**RE: Estates at Glendale Unit 2
Drainage Report and Grading and Drainage Plan
Engineer's Stamp Date 3-23-16 (File: B19D027)**

RE: **Estates at Glendale Unit 2**
Drainage Report and Grading and Drainage Plan
Engineer's Stamp Date 12-28-15 (File: B19D027)

ESTATES AT GLENDALE UNIT 2 AND UNIT 3	DRAWN BY MCM
	GRADING AND DRAINAGE PLAN	DATE 10-19-15
3/25/16		SHEET # ---
DRAWN SCALE P.L. # 14522		JOB # 21422

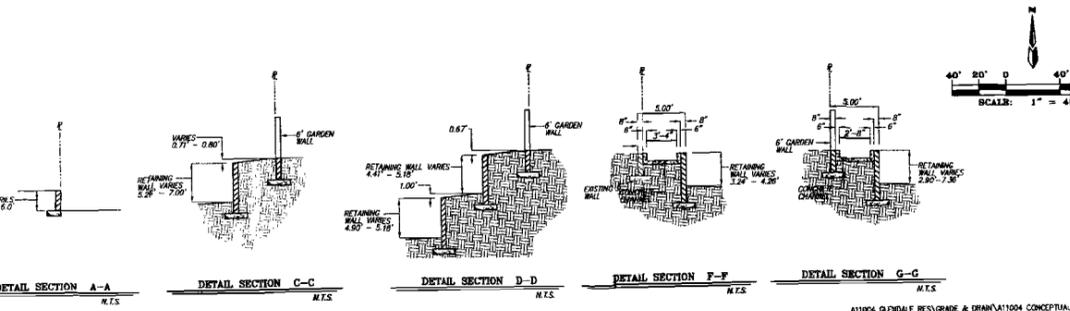
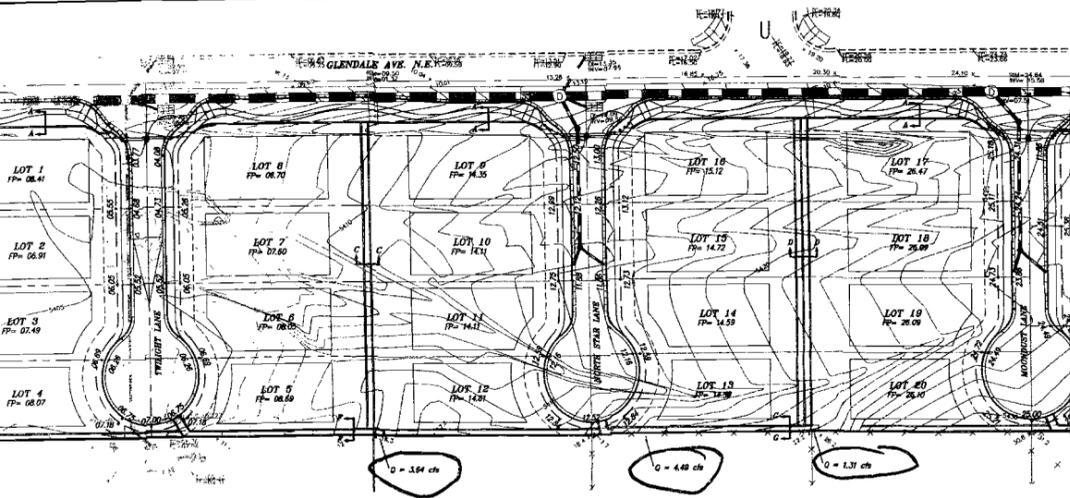
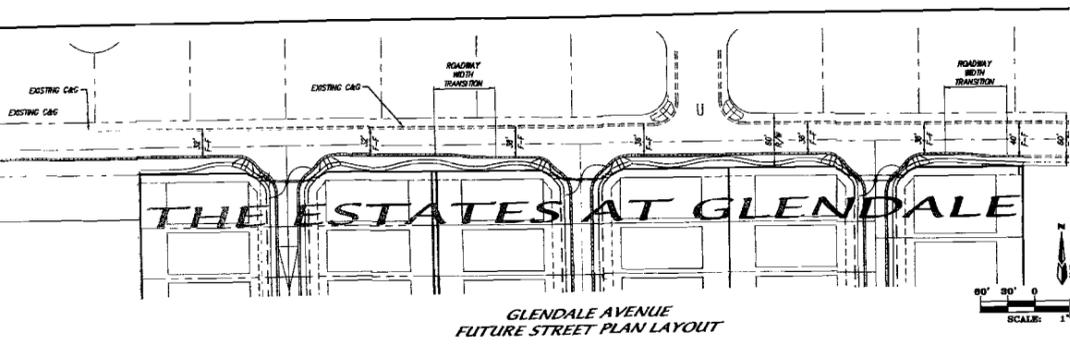
- PO Box 1293
Albuquerque
New Mexico 87103
www.cabq.gov
1. Submit an ESC plan to Curtis Cheme for approval. we have submitted
 2. Provide a Benchmark. we have added bench

3. Section A-A, show Property Line at Center of wall. we have centered wall
 4. Back yard ponding is not allowed as homeowners can eventually fill in. First flush ponds should be in the front. Revise report to state this. we have removed ponds

5. Lot 10 discharges to Lot 9 via a turned block in side wall. Correct leader to point to sidewall. we have corrected
 6. Call out a curb cut on existing channel, so that rear of lot 12 can discharge to channel. we have added note

7. Shift the SW culverts on Glendale to the west so that Lot 9 and pond will drain to them. We have moved and added wall drain section.
 8. The wall elevations along the western boundary are marked as either TW or BW, but per our conversation, those elevations are FG (finished grade) elevations on the eastern side of the existing retaining wall, which has a garden wall on top. Therefore,

- a. Call out existing retaining wall supporting an existing garden wall added
 - b. Change the abbreviations to FG for the elevations on the western side of wall. modified

9. Show the offsite basins on an offsite basins map. They should match those shown on the Mark Goodwin & Associates (MG&A) plan (stamped 7/13/12) that show the offsite boundaries and flows. ADDED MGA MAP AND MATCHING FLOWS

10. Since offsite basin (109 from MG&A) to drain thru 5 overturned blocks in wall. However, 5 adjacent blocks cannot be overturned to discharge into SW culvert. There must be some length of wall between overturned blocks (about 6'). Provide a series of overturned blocks, and provide a means to direct the flows to the cul-de-sac. WE HAVE SPREAD BLOCKS OUT, THEY WILL DISCHARGE TO THE CHANNEL THAT CONVEYS FLOWS

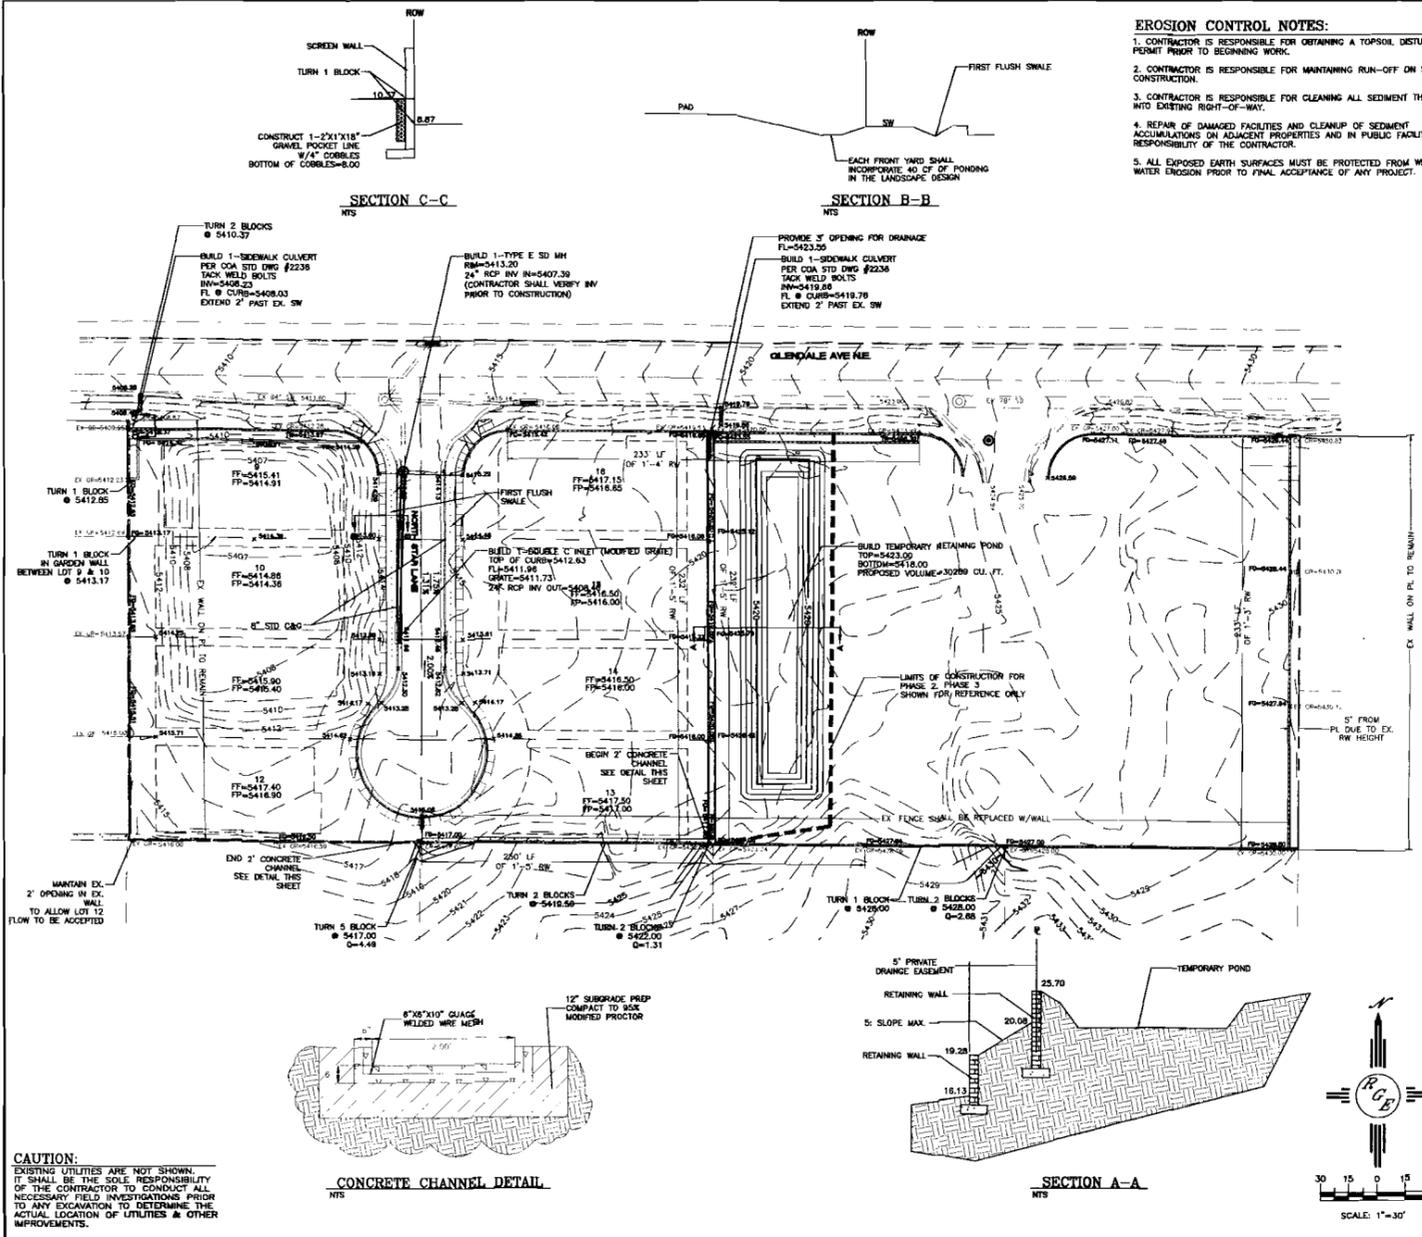
1. An approved ESC plan is required for ESC Permit.
2. Provide a Benchmark on the plan.
3. Lot 12 SW Corner: Show the existing channel in the SW corner that was built by the previous development. Show ToChannel elevation, and the FG adjacent to the channel. (Show that flows can enter channel)

4. Lot 12: SW corner: The Previous plans shows that the channel is 3.33' wide (the note says 2'), and so the opening in the West wall should be the same. The note leader needs to point to the opening in the WEST wall, stating that the opening is to remain, and should state that flows from both Lot 12 and from the Lot to the South are to be accepted.

5. Lot 12 SW corner: The Previous plans show that a 3.33'x0.67' opening with a steel grate was provided in the existing wall for the Lot to the south to discharge through. Indicate that this opening is to remain. There needs to be a second note stating that the opening is to remain to accept flows from the Lot to the South.

6. First Flush ponds are shown in Section B-B, however, show a depth. Also show in the plan view the approximate location and area of pond needed to capture 40cfs as stated in Section B-B. Show first flush calculation.

7. The SW Culvert at NW corner of site shifted East, but elevations remained unchanged. Verify elevations on the Work Order.
8. Lot 9: Overlapping text of TW elevations with existing contour label.

9. Fade back existing contours.
10. Show how overflow from pond will discharge to the SW Culvert.
11. Lot 13 South Wall: provide a series of evenly spaced block opening that would allow 4.49 cfs to flow through rather than 1 location of 5 overturned blocks.

12. The 1.31 cfs should enter thru overturned blocks on South wall, on undeveloped site. Move location of overturned blocks slightly east so that flows from that site can enter.

13. Detail and dimension channel that will allow the 1.31 cfs from offsite flows along with the 4.49 cfs to flow to the SW culvert at the end of the cul-de-sac.

14. Call out and the number and width of SW culverts needed at end of cul-de-sac.
15. No revised report submitted.
16. No pond volume calculations submitted. Please submit.

17. Add to the Legend the hatch pattern used for existing Retaining Walls. Is the existing south wall a screen wall? If so, it does not match the screen wall hatch pattern.

18. If there is to be "recontouring" on the lots to the south, then show on the plan and add the following note: CONTRACTOR MUST COORDINATE GRADING ON OFFSITE LOTS WITH NEIGHBOR(S) TO THE SOUTH PRIOR TO BEGINNING WORK

19. Note the type of Curb and Gutter on the plan, and the extents of the different types. Is it Standard Curb and Gutter. Note so in the Legend.
